RE: REQUEST UNDER SECTION 369 OF SPA FOR PERMISSIBLE CHANGE TO EXISTING APPROVAL FOR RECONFIGURING A LOT AND MATERIAL CHANGE OF USE (MULTI-UNIT HOUSING) AT 24 MUDLO STREET, PORT DOUGLAS, MORE PARTICULARLY DESCRIBED AS LOT 60 ON PTD20911

The following revised drawings are included for reference as **Attachment 2**:

Revised Plans

MUDLO STREET VILLAS

ELEVATION - NORTH
1:100

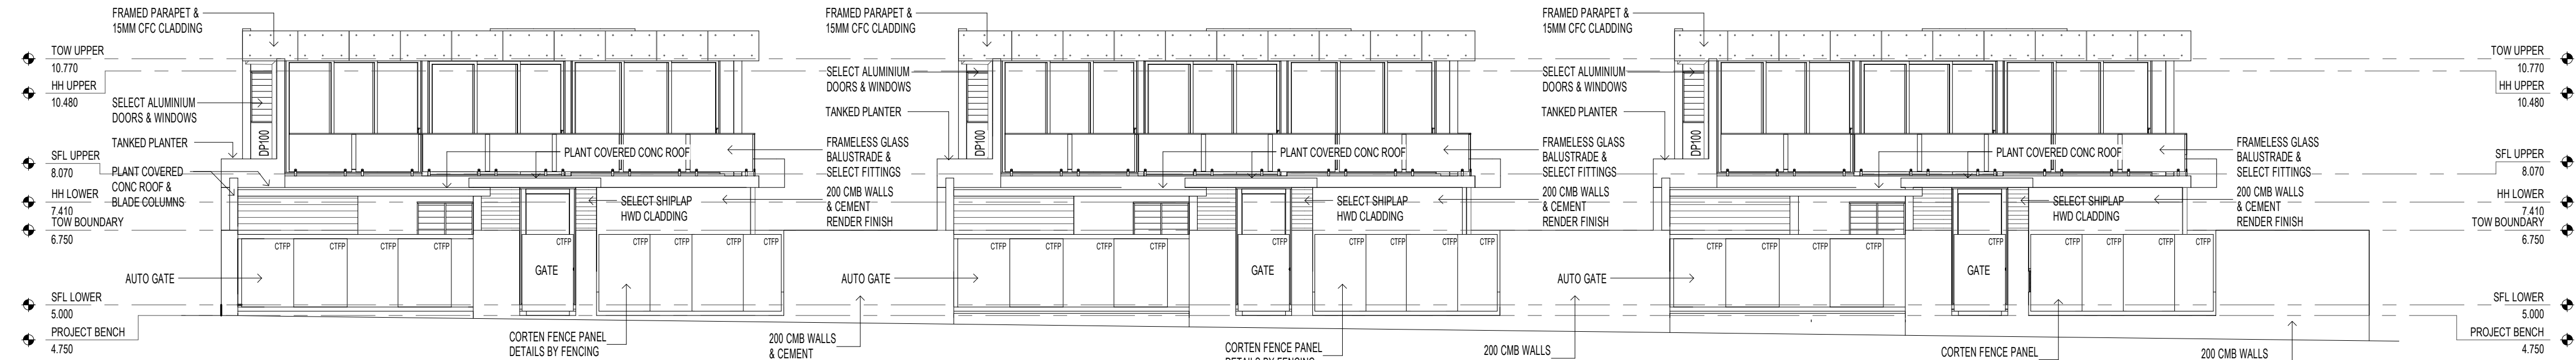
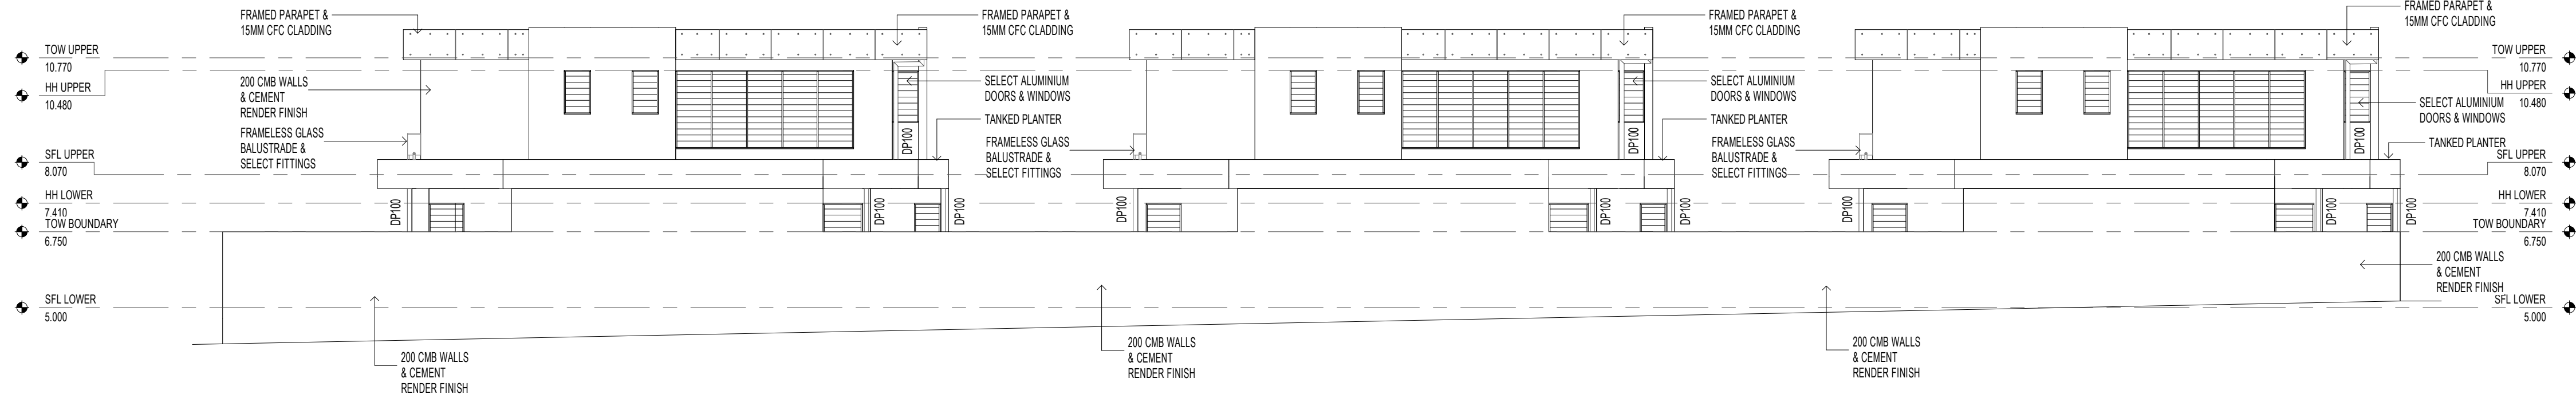
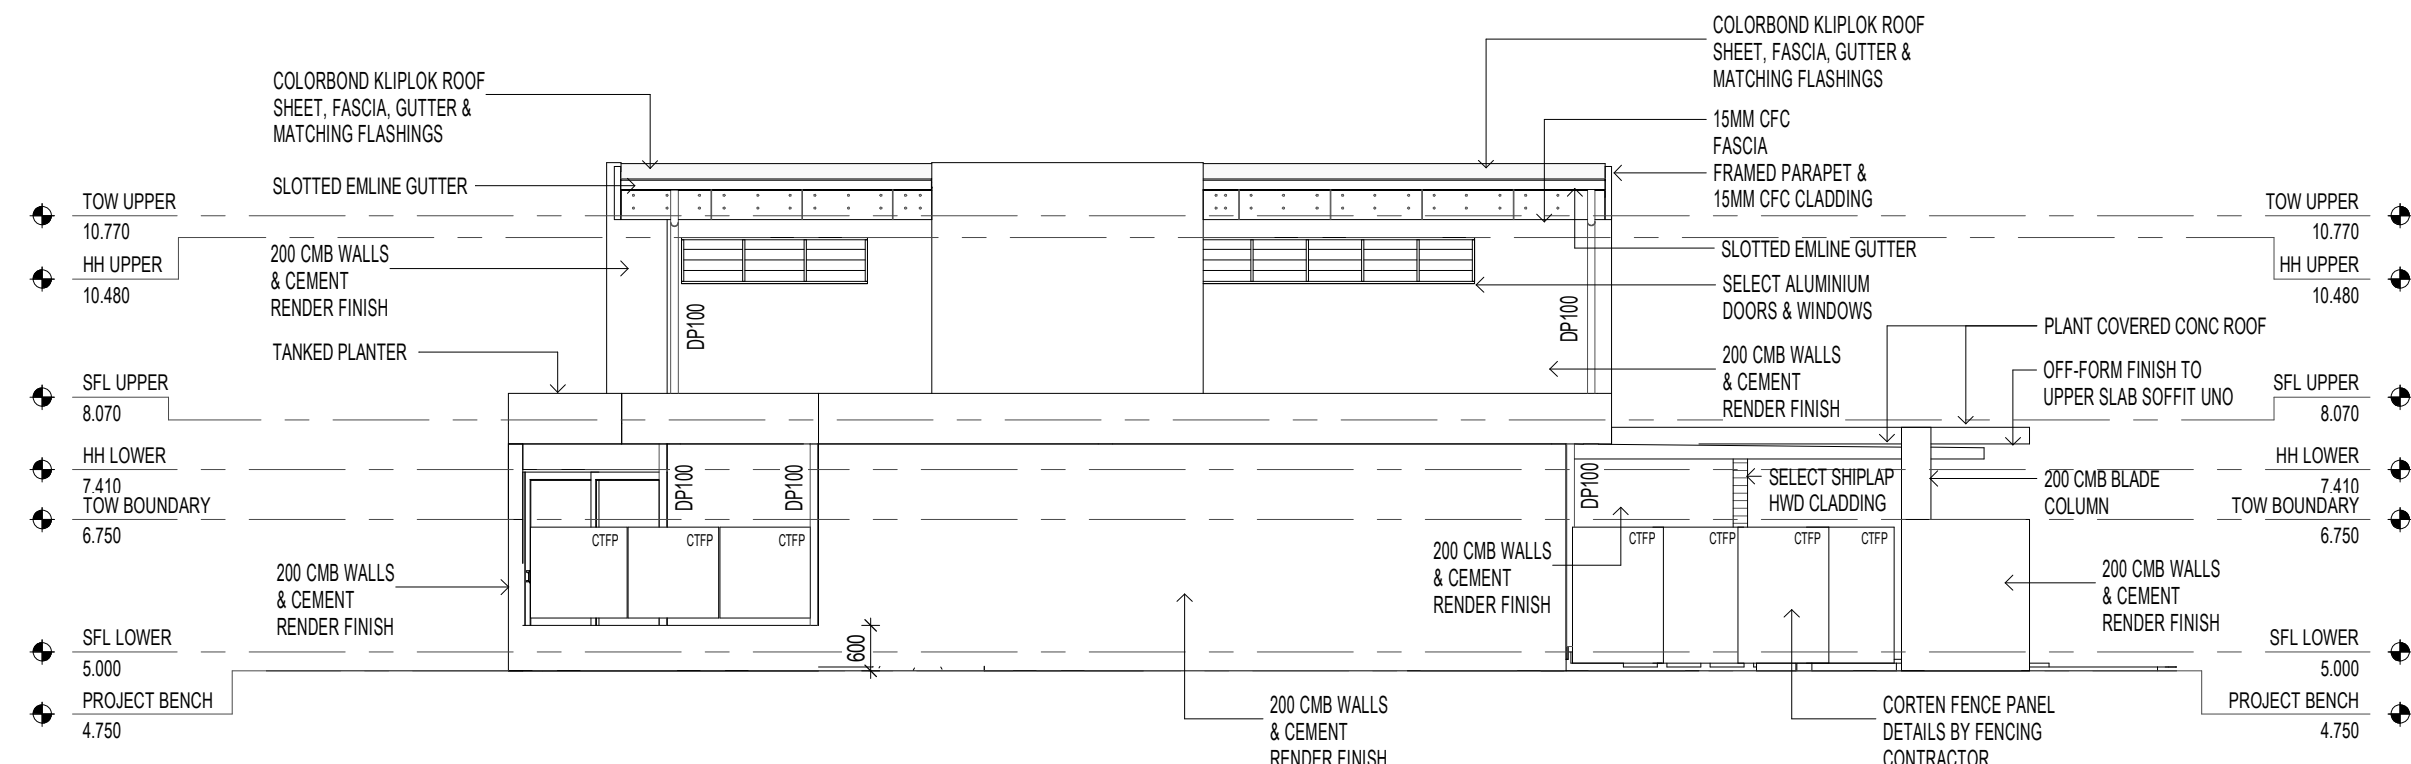
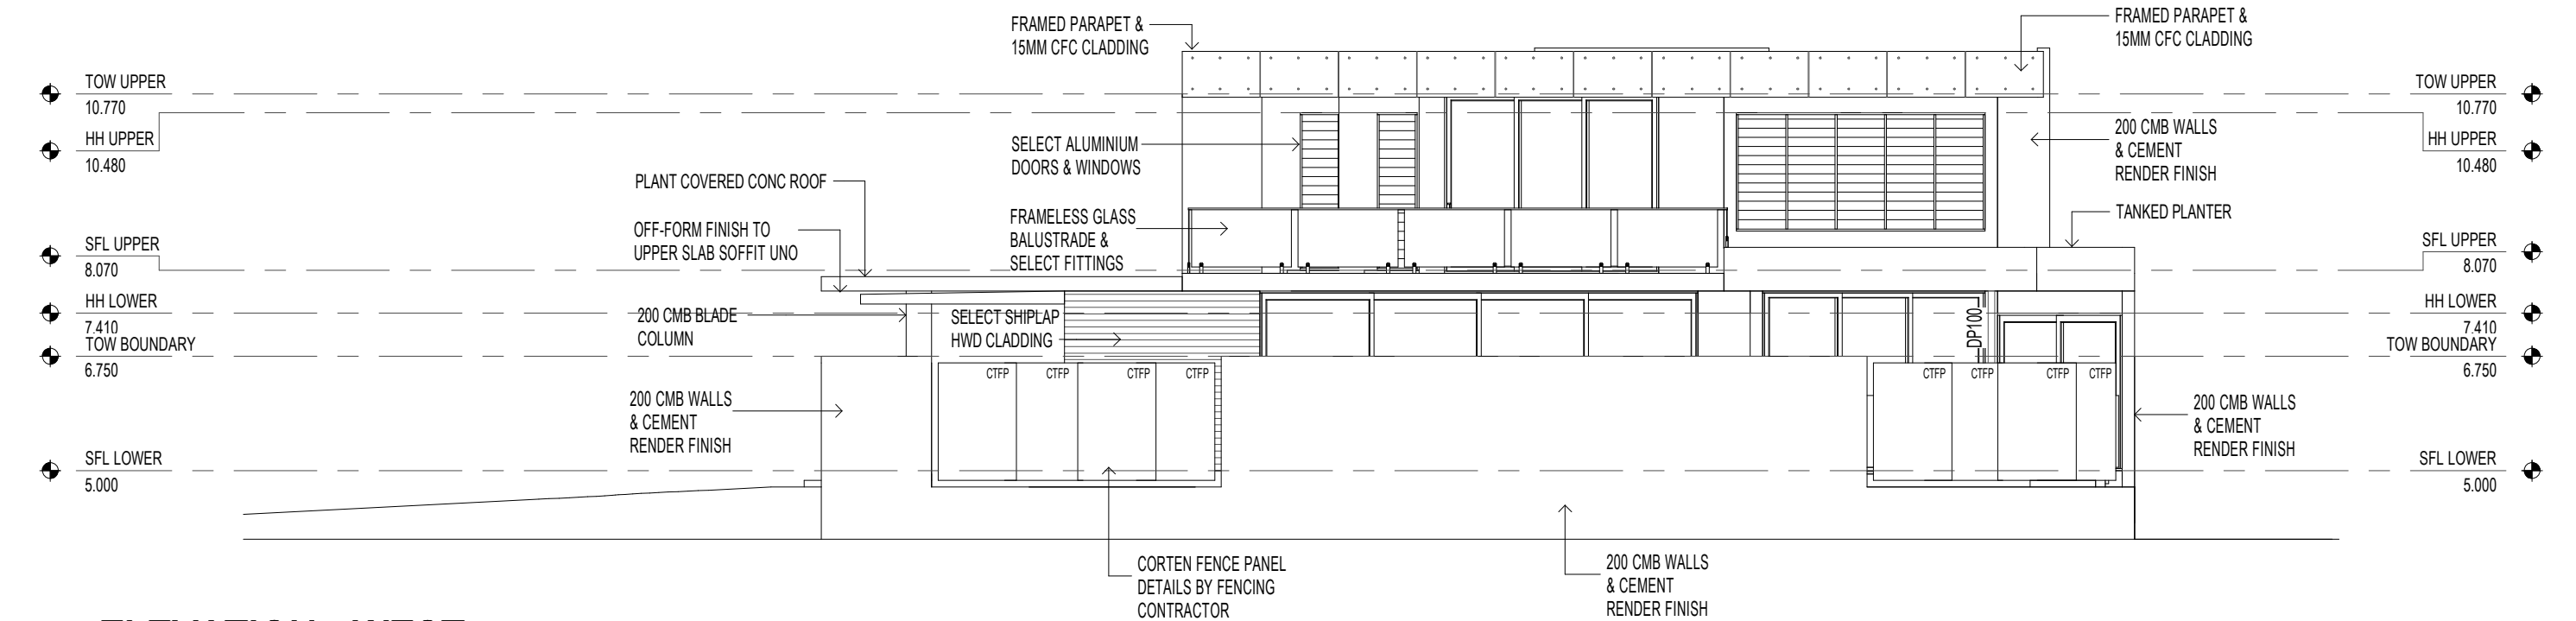
- Site Plan – Sheet 0
- Floor Plans – Sheet 3
- Elevations – Sheet 4
- Area Plan Site Cover – Sheet 5
- Street-View Renders.

Taking the above into account, the applicant is proposing a high-quality, visually appealing concrete roof structure, embellished with vine-type vegetation. As is evidenced by the Street View Renders, the change blends in seamlessly with the existing approved built form and continues to achieve a highly appropriate streetscape aesthetic.

SHEET NAME: AREA PLAN SITE COVER

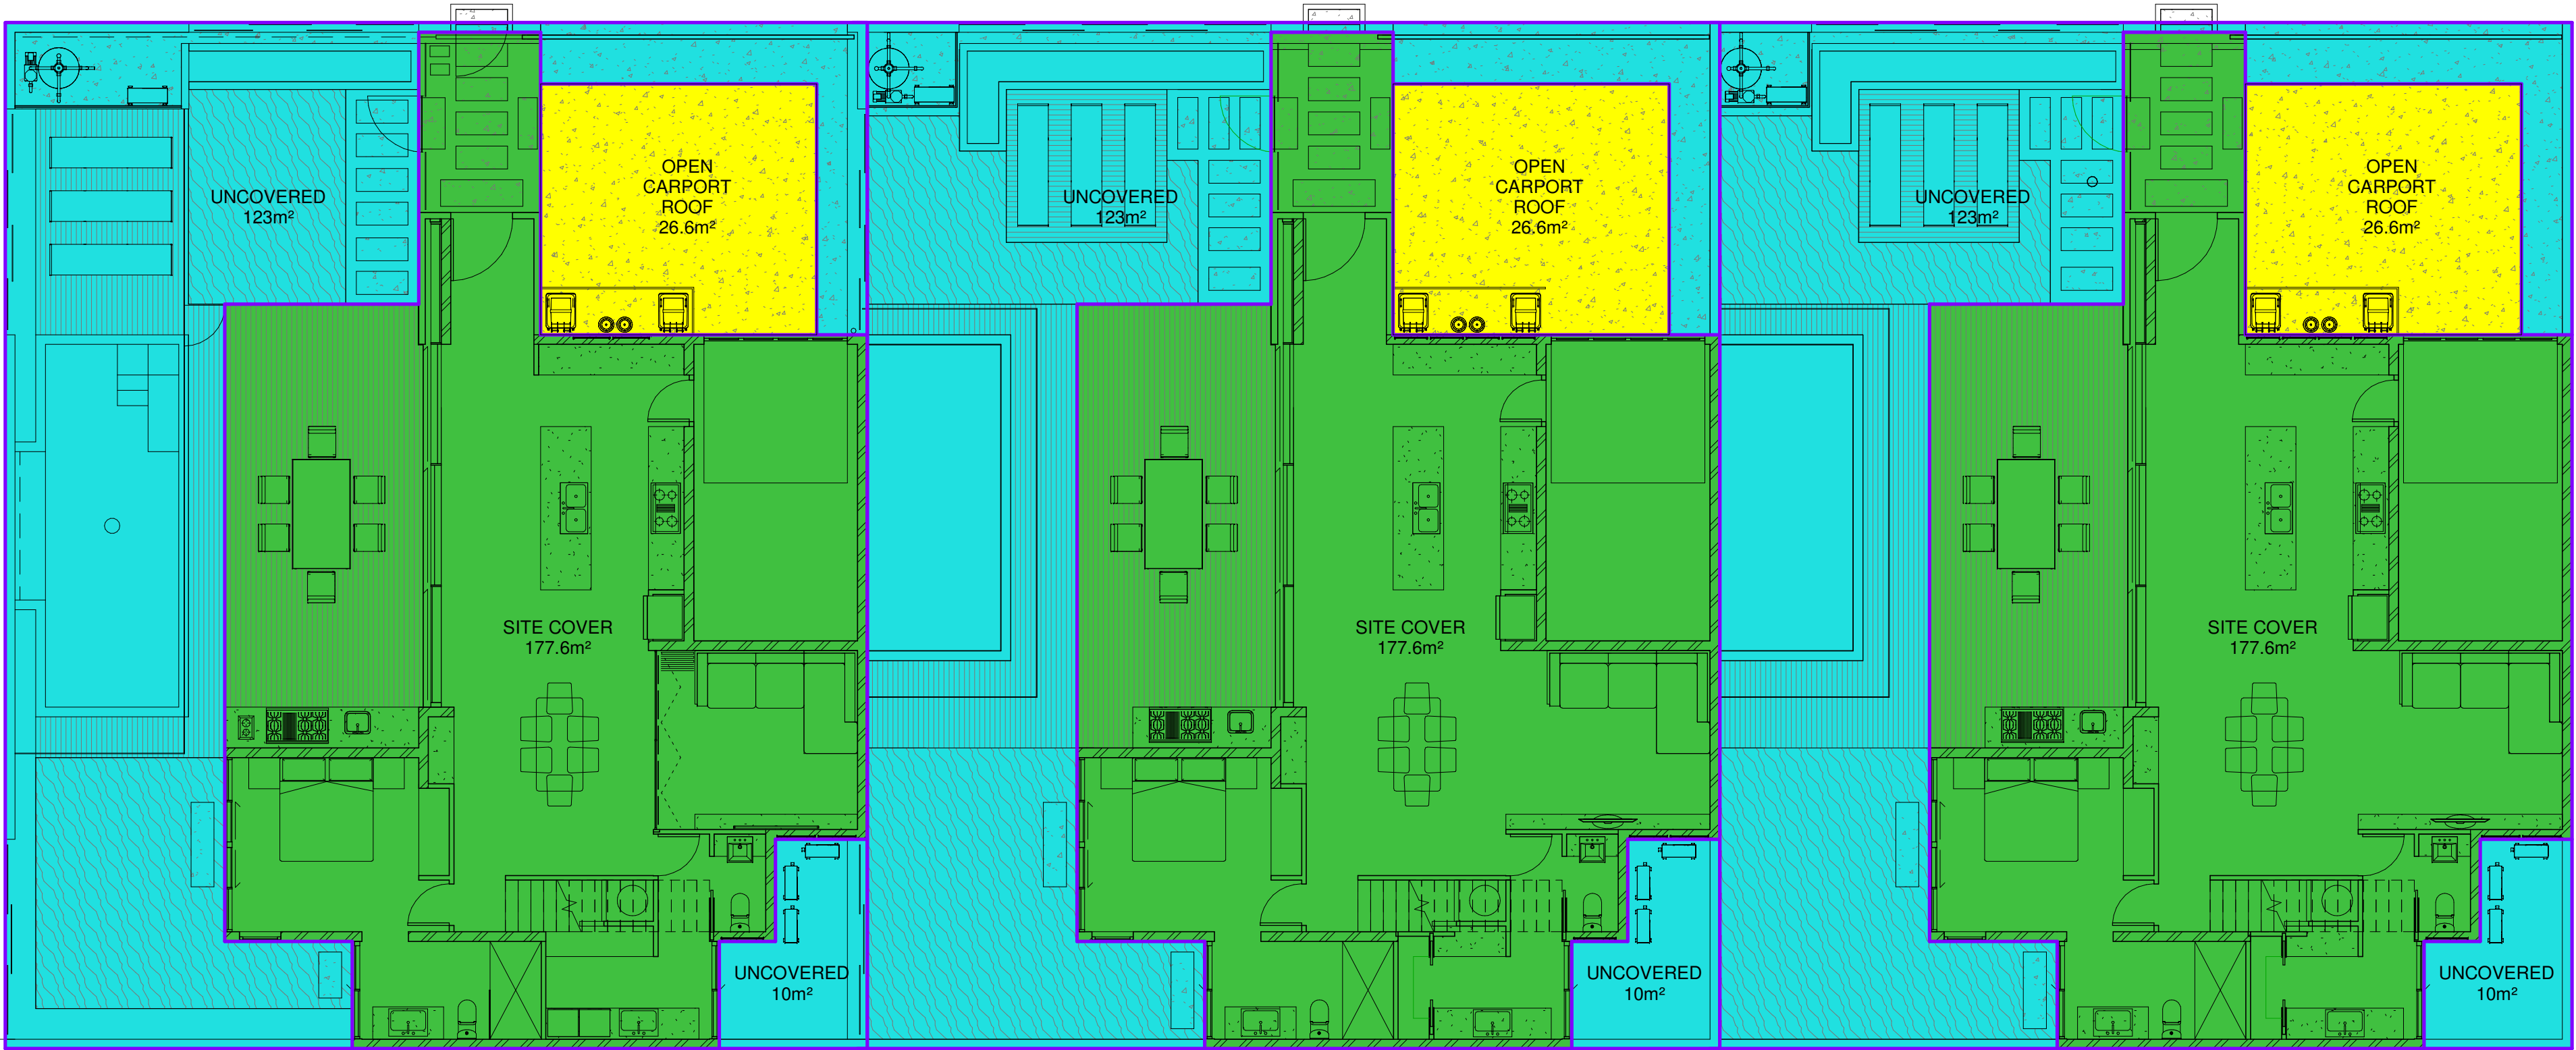
It is noted that the proposed change results in an increase in site cover by approximately 8%, up from approximately 52% to approximately 60%. While this figure exceeds the Douglas Shire Council 'acceptable solution' of 45% (under the Tourist and Residential Planning Area Code), it is considered to remain compliant with the corresponding 'performance criteria' which states:

We submit that the proposed additional roof structure does not create a bulky or visually obtrusive built form, but rather blends in well with the existing approved built form, as discussed above.

It is further noted that the proposal is only 2 storeys in height, whereas 3 storeys is permitted on the subject site. The omission of a third level is considered to provide some leeway in terms of site cover when determining overall building bulk.
